5.3 NO. 3 (LOT: 43; D/P: 1237) ALMA ROAD MOUNT LAWLEY - PROPOSED GROUPED DWELLING (AMENDMENT TO APPROVED)

To consider an application to amend development approval for a grouped dwelling at No.3 Alma Road, Mount Lawley (subject site).

This amended application seeks to make changes to the previous approval for a grouped dwelling, including removal of the roof terrace. The amendment would still result in the same three bedroom, two parking bay grouped dwelling development oriented to the eastern right of way (ROW).

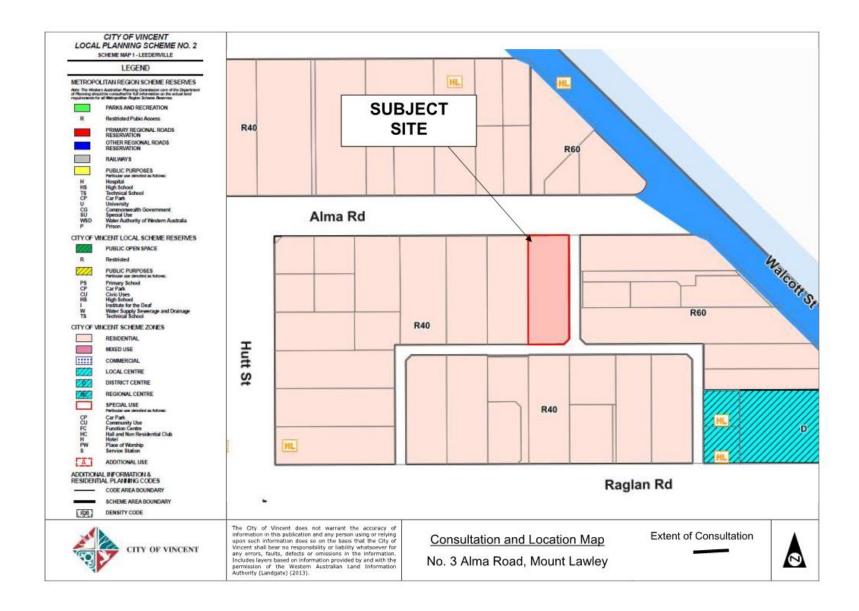
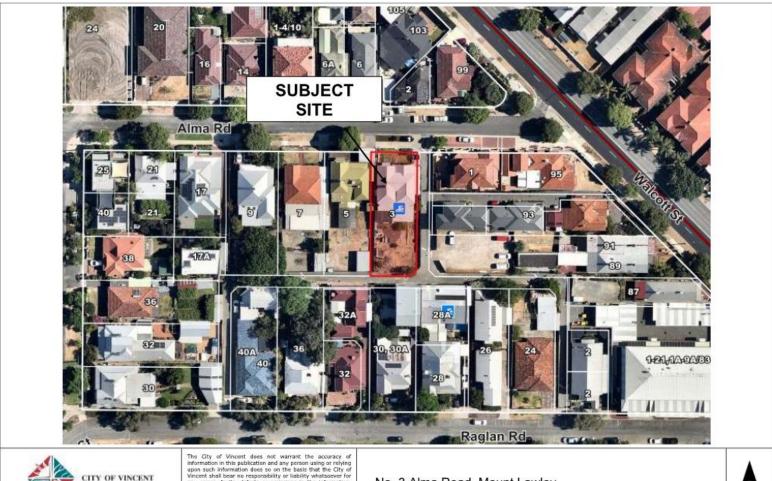
The proposed removal of the roof terrace through this application would result in the balcony on the first floor becoming the primary outdoor living area, resulting in new departures to the deemed-to-comply standards of the R Codes.

The deemed-to-comply standards of the R Codes require the provision of an outdoor living area with a minimum dimension of 4 metres, and a maximum of 13.3 square metres without permanent roof cover.

The balcony would result in an outdoor living area with a 3.6 metre minimum dimension and 9.9 square metres without permanent roof cover. The application does not propose any change to the size or design of this balcony area from the previous approval.

The balcony outdoor living area satisfies the relevant design principles of the R Codes for the following reasons:

- <u>Functionality:</u> The balcony is accessible from habitable rooms of the dwelling, being the kitchen and dining rooms to optimise its function and use;

- <u>Size:</u> The 3.6 metre width of the outdoor living area is compensated by the length of 5.7 metres. The dimensions of the balcony enable the space to be a usable extension of the habitable rooms. The balcony is 20.4 square metres in area, satisfying the minimum 20 square metres deemed-to-comply standard:

- <u>Weather protection:</u> The 10.5 square metre covered portion of the balcony would support the use of the space all year round. The remainder of the balcony is open to allow for sufficient access to sunlight and ventilation to the dwelling and its occupants, enhanced by the northern aspect of the balcony; and

- <u>Second outdoor living area:</u> There is a second outdoor living area at ground level which is accessible from bedroom 3 and that is 36.3 square metres in area. Deep soil areas and canopy cover from three trees are provided to this outdoor living area. The total area of the ground and upper floor outdoor living areas would be 56.7 square metres; areas which are capable for both passive and active use of future occupants.
